Appl. No. 09/929,398
Amdt. dated November 21, 2005
Reply to Office Action of August 26, 2005

Amendments to the Drawings:

REMARKS/ARGUMENTS

Fig. 4

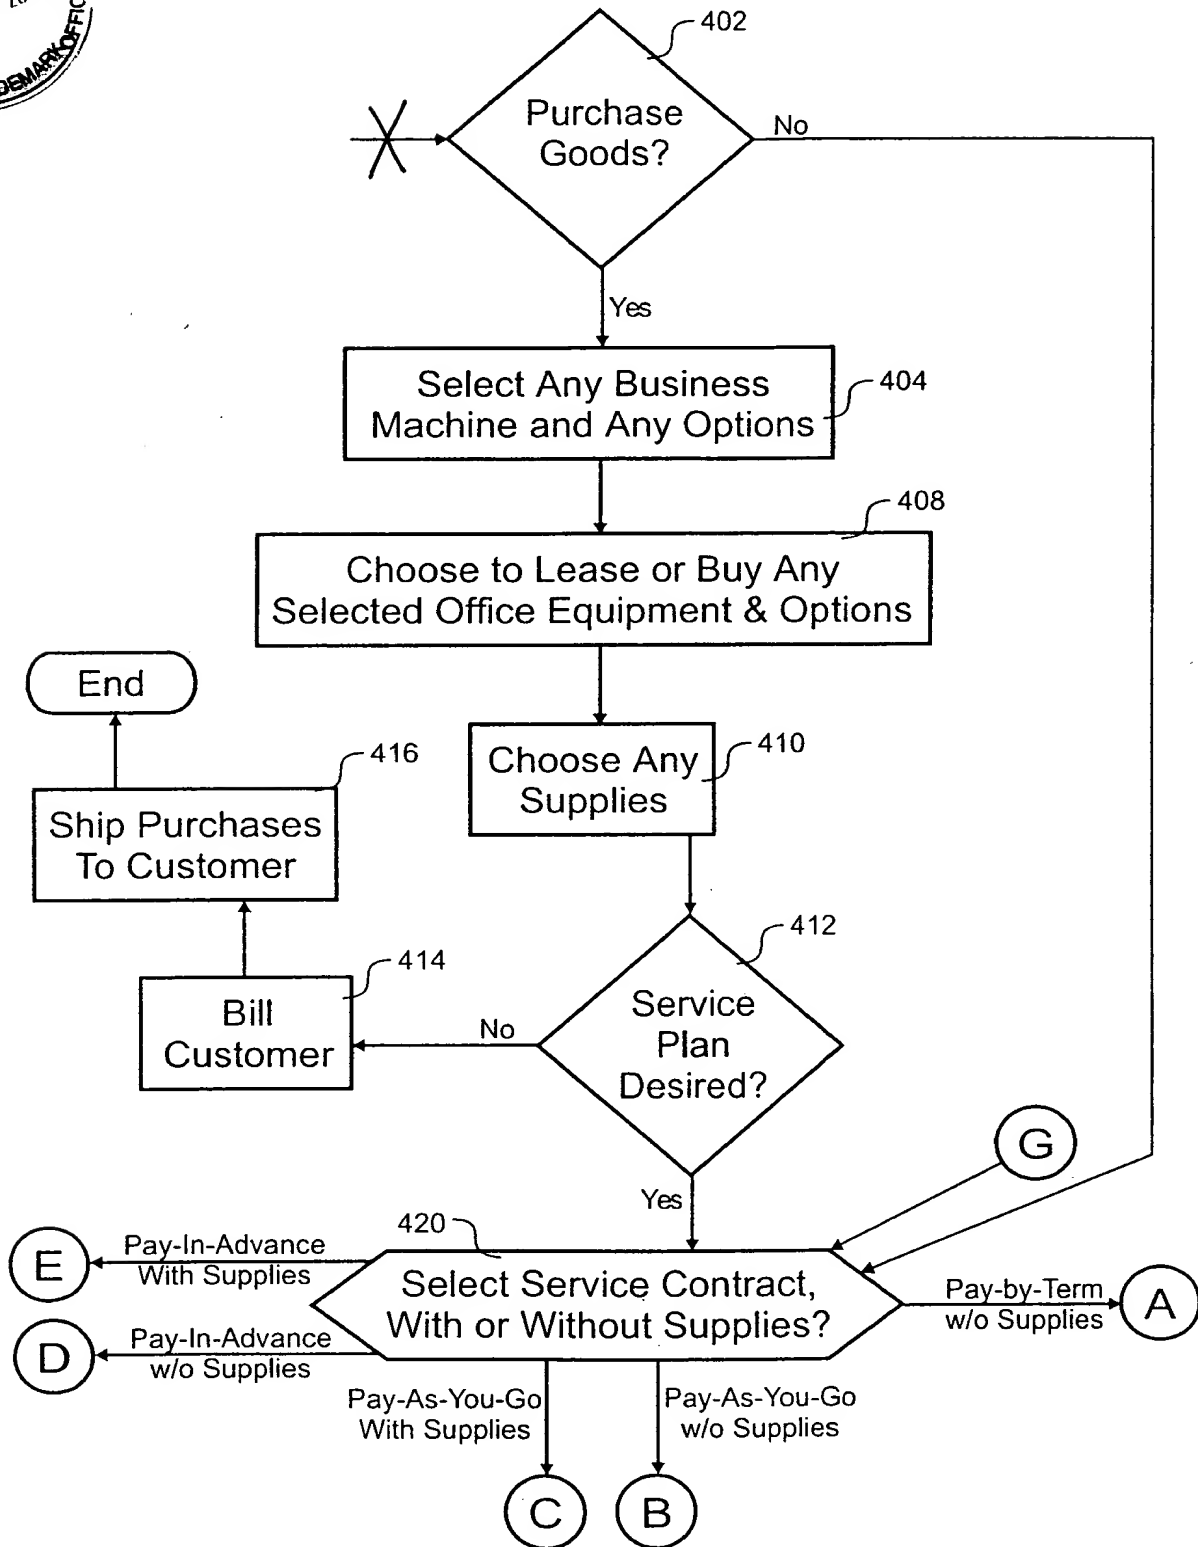
The attached sheets of drawings include changes to Fig. 4, 5D, 5E and 6. These sheets, which include Fig. 4, 5D, 5E and 6 replaces the original sheets including Fig. 4, 5D, 5E and 6.

Regarding objections in paragraph 1a and 1e-1k, Figures 4, 5A-5E, and 6 the corresponding amendments have been made as the Examiner suggested. A redlined set of Figures is submitted along with formalized versions for entry upon approval.
